Model: PC3000	October 11, 2013
Serial #: See "Models Impacted" section	
Product Bulletin # Catwalk 32

## PC3000 Heavy-duty Guard for Safety Curtain Laser Assemblies Upgrade

Figure 1: Ramp End Upright Post Before Upgrade

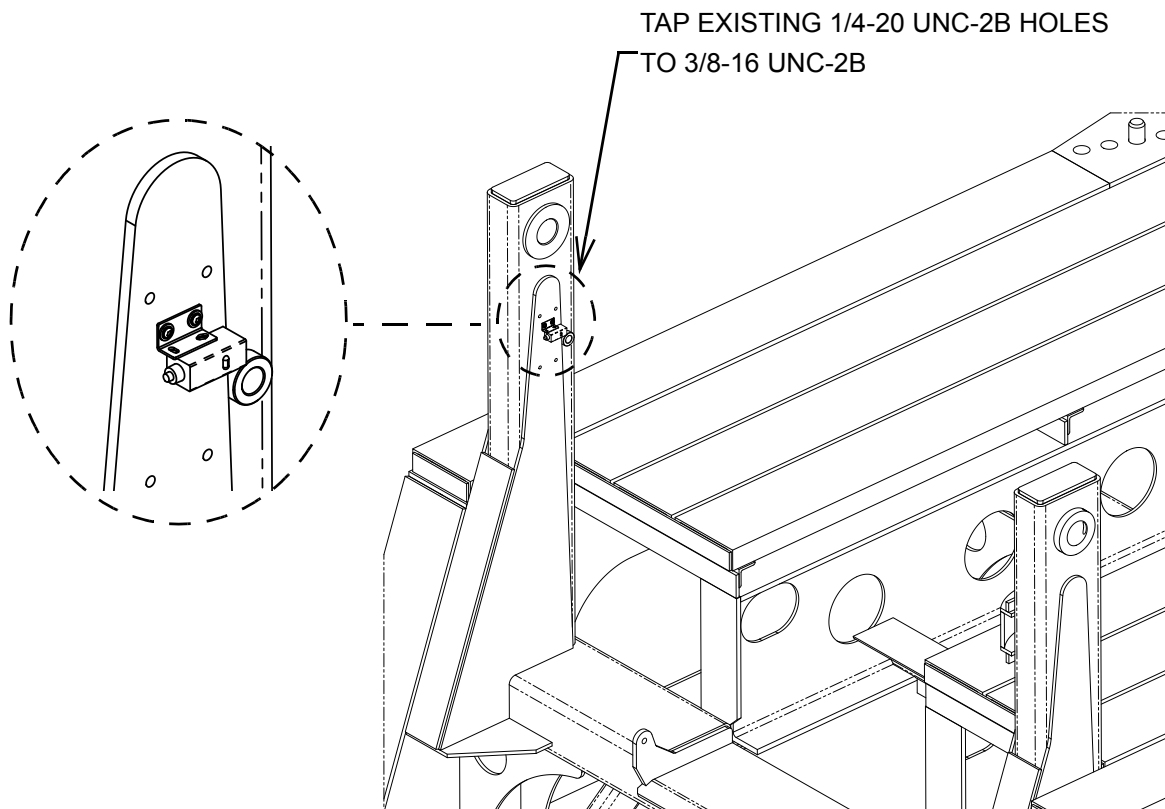
1. Before beginning the installation, disconnect catwalk electrical power and follow local lockout/tagout procedures.
2. Remove the two existing safety curtain laser guards on the ramp end.
3. Match drill and tap the existing 1/4-20 UNC-2B hole patterns to 3/8-16 UNC-2B on the two ramp ends (Figure 1).

Figure 2: New Heavy-duty Guard Installed

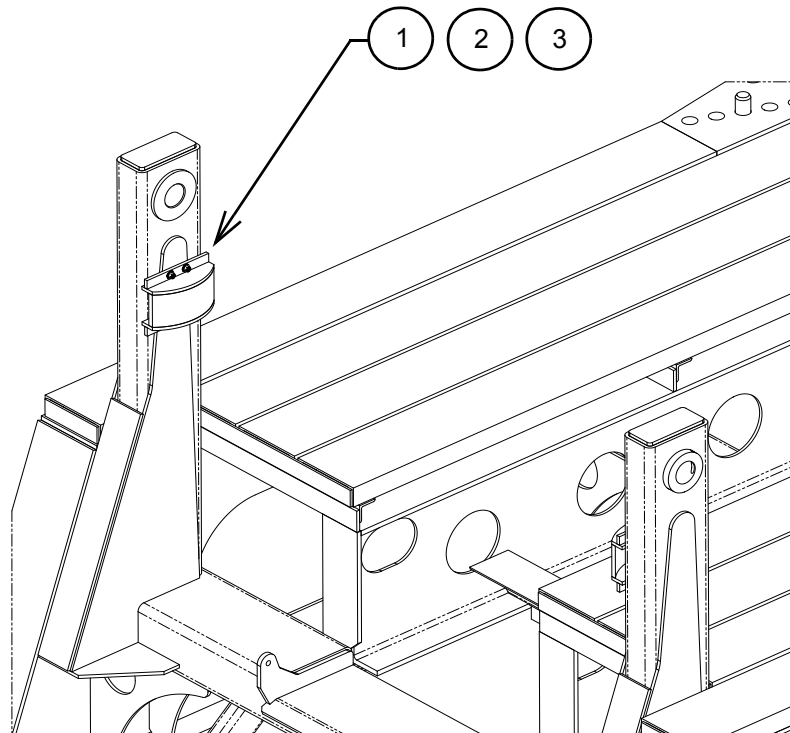
4. Ensure the sensors are aligned, and install the safety curtain laser guard using the provided hardware and thread locking compound (Figure 2).
